TOWN OF SMITHFIELD BOARD OF ADJUSTMENT AGENDA PACKET

Meeting Date: Thursday, February 23, 2023

Subject: 1109 N Brightleaf Blvd Variance
Department: Planning
Presented by: Mark Helmer, Senior Planner
Presentation: Yes

Agenda Item: BA-23-02
Date: 2/23/23

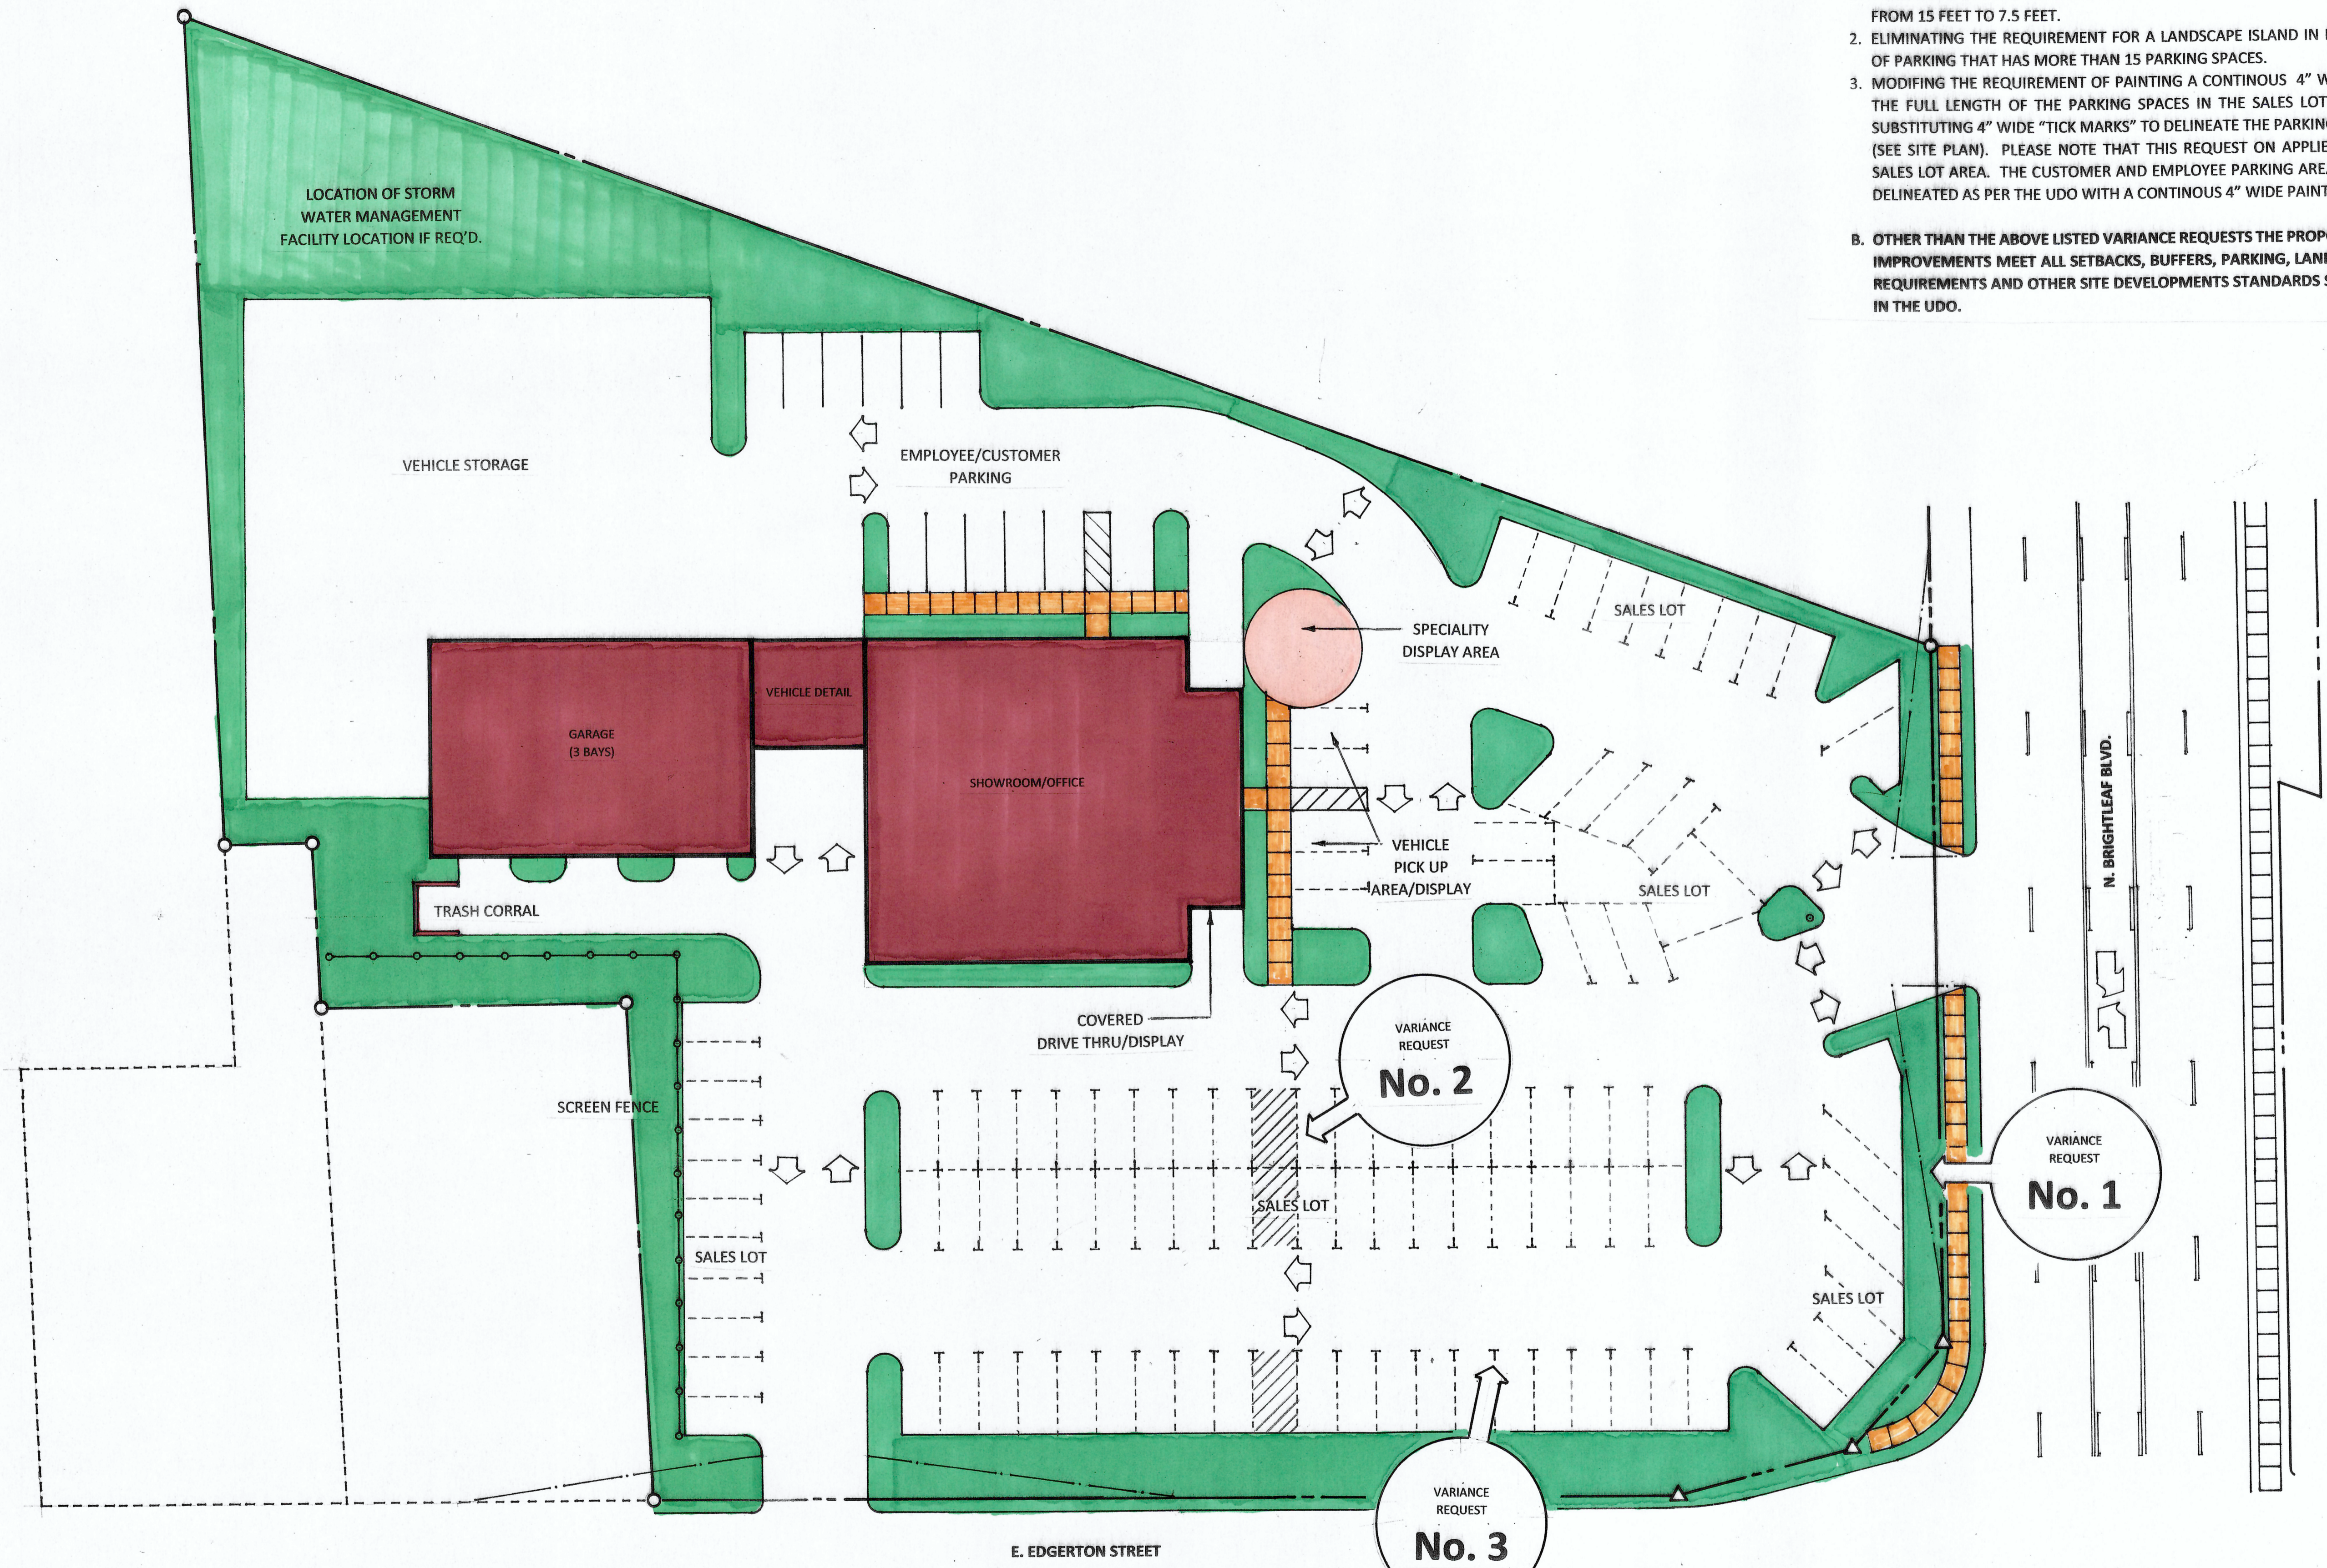
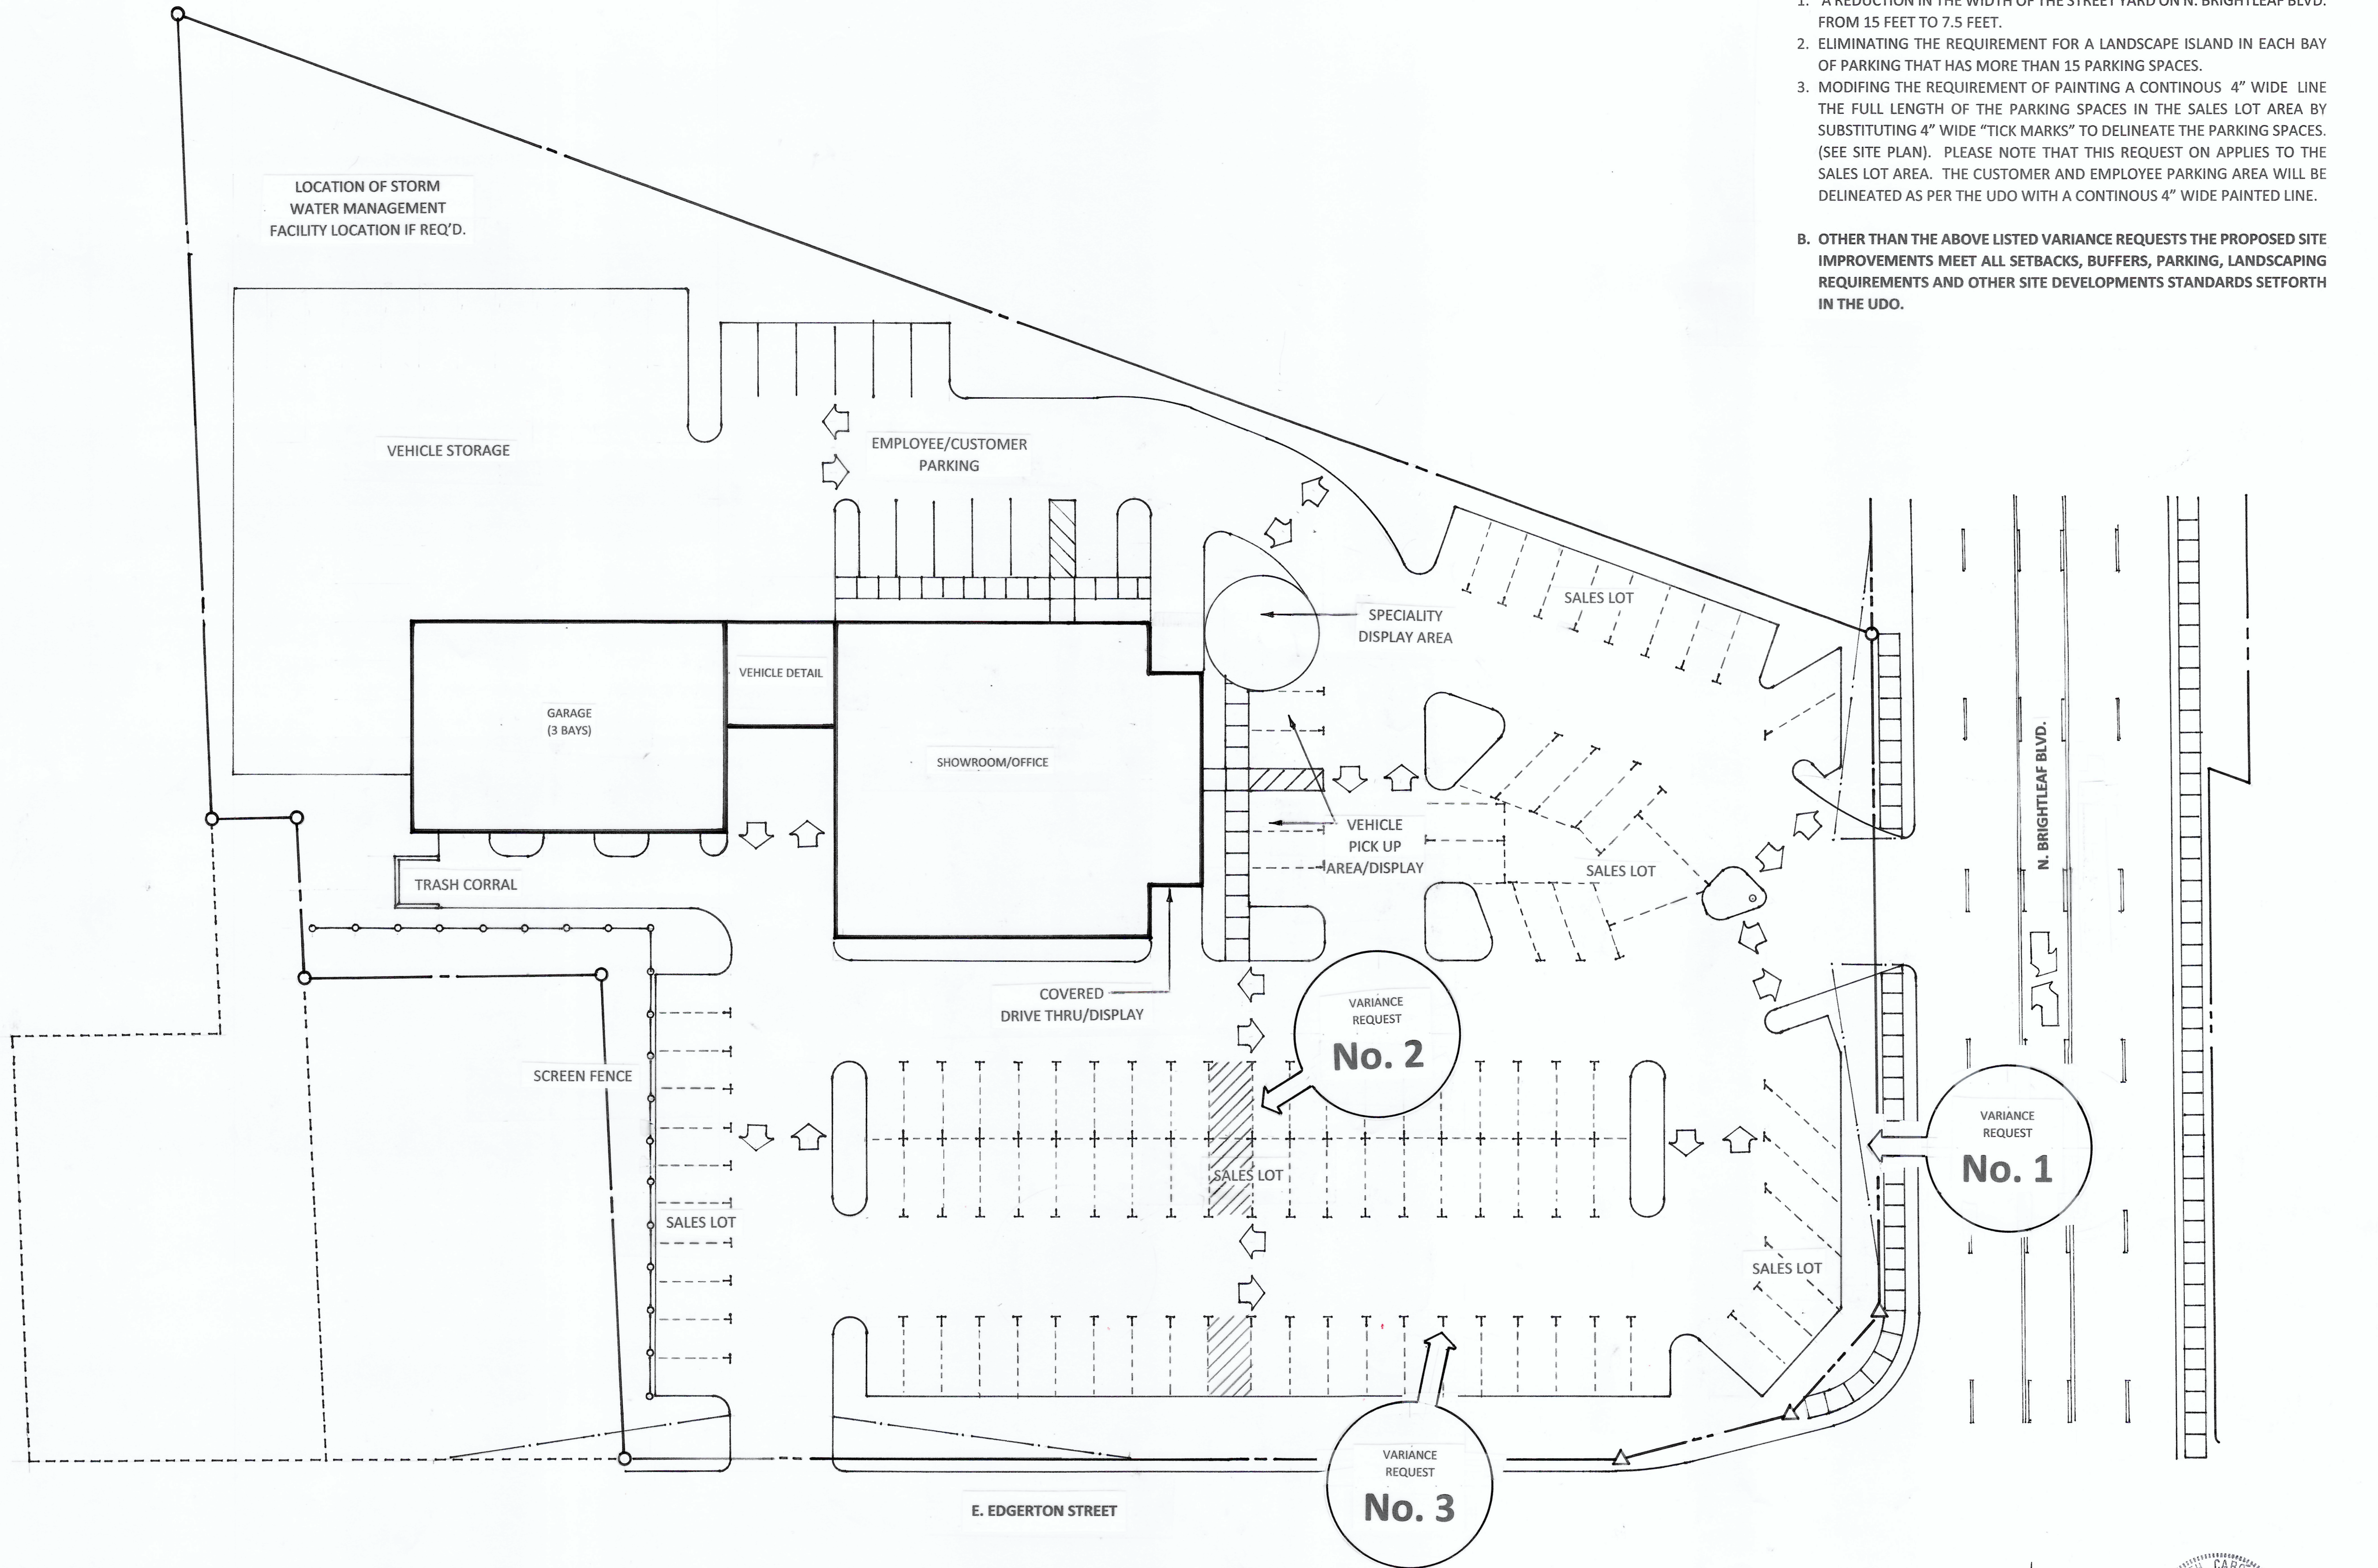
The applicant is planning to expand the Perfect Ride car sales lot into a more modern used car dealership. The update to the facility triggers compliance with current zoning standards including landscaping, dumpster screening, paving, curb and gutter and parking. The applicant is requesting 3 variances, and each should be considered by the Board of Adjustments separately.

Street Yards shall be provided with a minimum depth of 50% of the required front or corner side yard setback as measured perpendicular to the street right of way, provided that no street yard in excess of 15 feet in depth shall be required. The width of the planting strip may vary, but the minimum width cannot be less than seven feet and the average width shall be at least ten feet. The planting area must be covered with living material, including trees, shrubs and/or ground cover, so that no soil is exposed at a rate of two canopy tree and 2 shrubs per every 100 linear feet of road frontage. Canopy trees can be replaced by understory trees if in conflict with overhead utilities. Required trees shall be placed in a planting strip on private property and not within the street right-of-way. No required street yard tree can be planted further than 15 feet from the edge of the right-of-way to meet this requirement.

The second variance request is to eliminate the requirement for a landscape island every 15 feet (UDO Section 10.13.1.7.3):

10.13.1.7.3. Landscaped islands shall be installed at each block of 15 consecutive parking spaces and at the ends of all parking rows. Landscaped islands shall contain at least 100 square feet in area and be at least 8 feet in width, measured from back of curb to back of curb.

The purposed of Section 10.13.1.7.3 is to break up expanses of pavement and to shade parking areas.

Planning Staff recommends the Board of Adjustment deny each of the requested variances, BA-23-03, based on the finding of fact for each.
